**City of Bellevue  
Development Services Department  
Land Use Staff Report**

**Proposal Name:** 112th Short Plat

**File Number:** 13-123064-LN

**Preliminary Short Plat Comments**

Figure 1 – Preliminary Short Plat Proposal

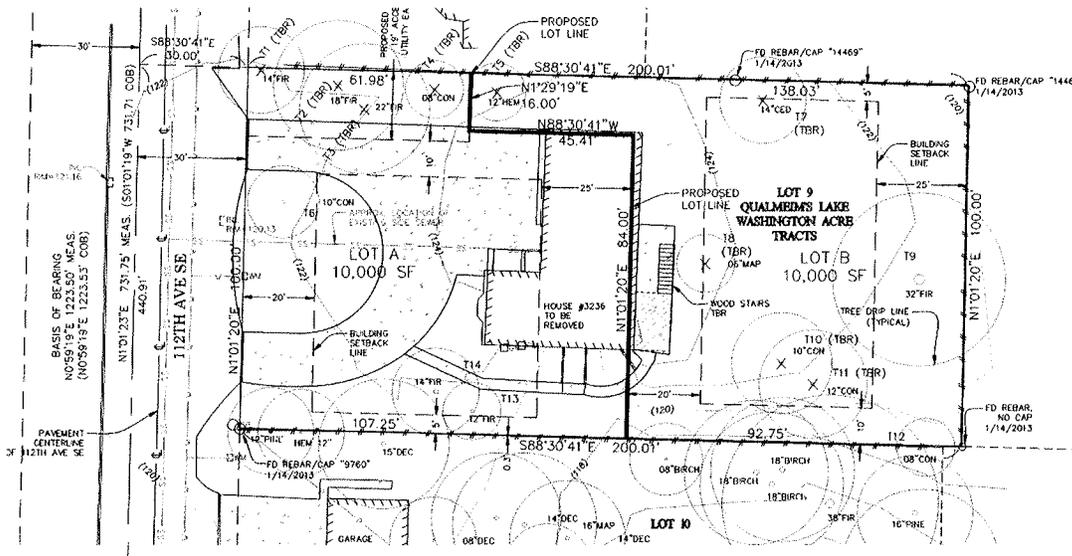
As defined by Land Use Code 20.25H, the site does not contain any critical areas; however, the property currently contains thirteen (13) significant trees consisting of Douglas Fir, Spruce, Hemlock, Cedar, Maple and Pine (186 diameter inches). The applicant proposes to retain five (5) of these trees, which equates to approximately 40% of the total diameter inches of the significant trees on the site.

**JAYMARC HOMES**  
 PRELIMINARY SHORT PLAT

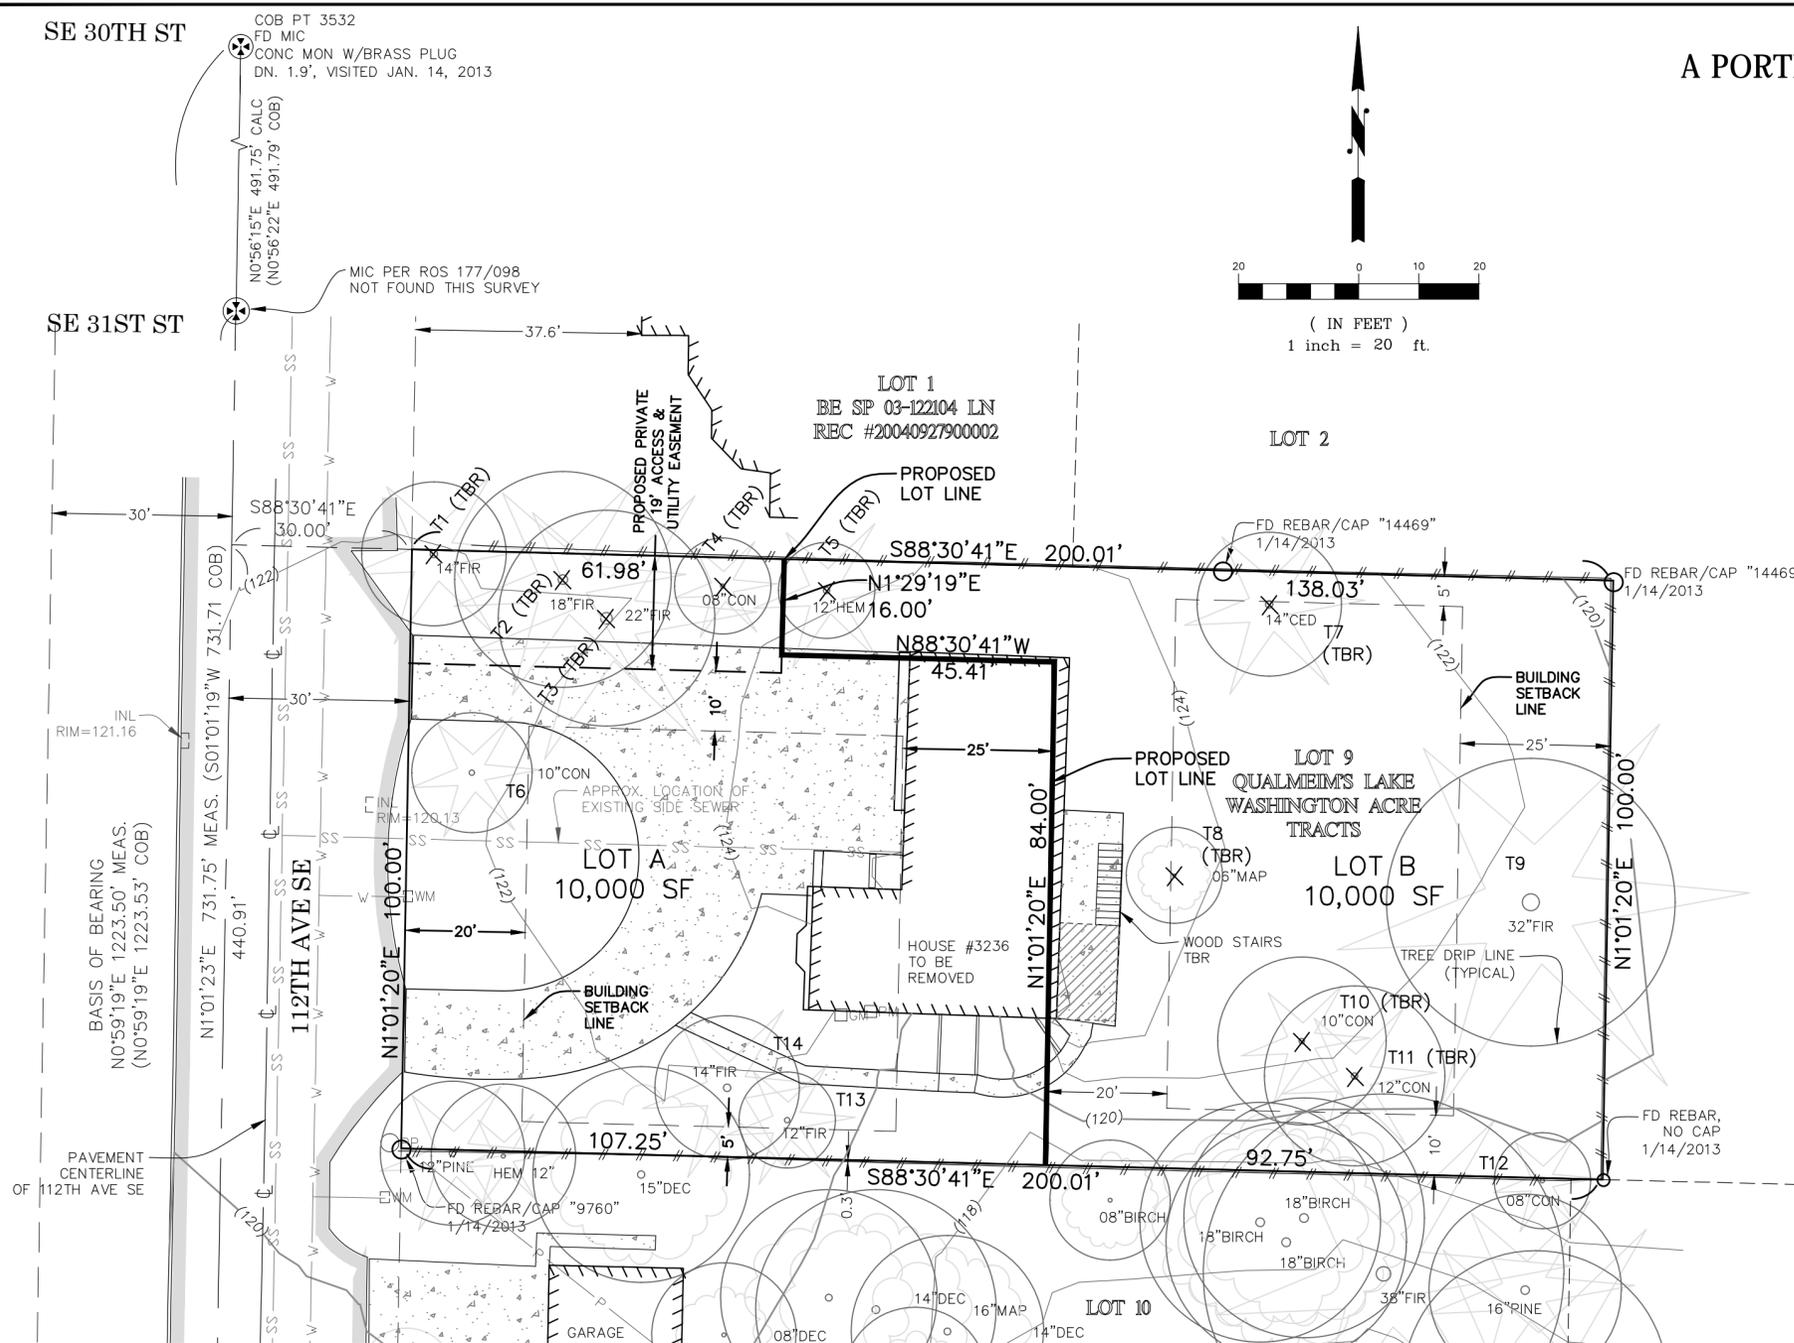
The City of Bellevue urges the applicant to save as many trees as possible. The final short plat shall portray a minimum of 76 diameter inches of existing significant trees to remain, as proposed. In order to maintain a minimum of 30% of the existing diameter inches of significant trees on the site, the two Douglas Fir trees (T-13 and T-14) must be saved during plat infrastructure and the subsequent construction of new single-family dwellings. A Tree Preservation Plan that portrays the drip-line, the diameter size, and common name of each significant tree to be retained must be recorded with the *final short plat mylar* (recorded with King County). This Tree Preservation Plan must also contain the following note:
